**Re: Dunkin Donuts (#1814067)/Pre-Application Meeting held 07/25/2024**

Re: ***Dunkin Donuts (#1814067)/Pre-Application Meeting held 07/25/2024***  
***Comment Responses to Pre-Application comments***

**Wallace Design Collective has reviewed the comments provided on 08/08/2024. Our comment responses to the Pre-Application comments are as follows in **RED**:**

**Figure 2.6-1: Condition 1**

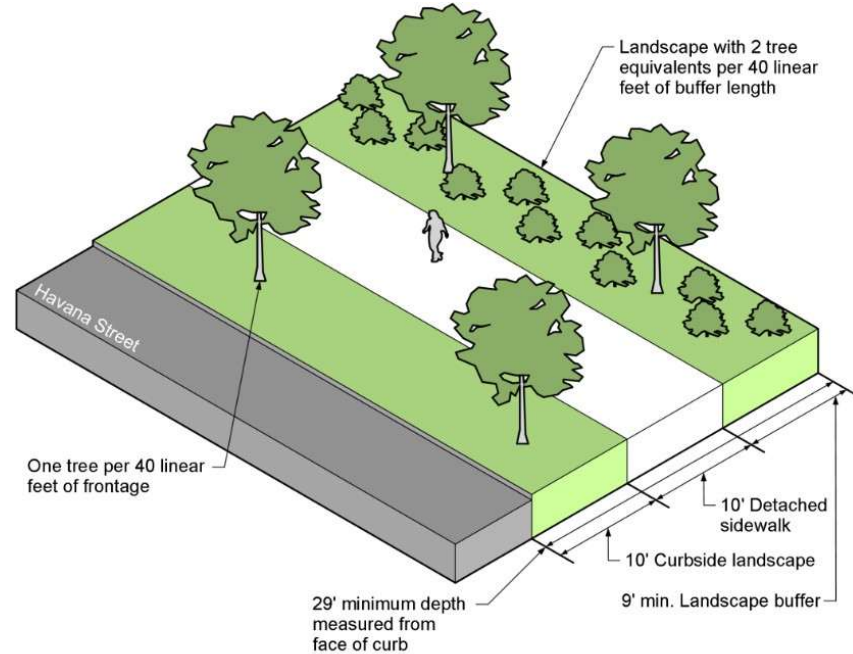
- Refer to Figure 2.6-1 for Condition 1 requirements below.
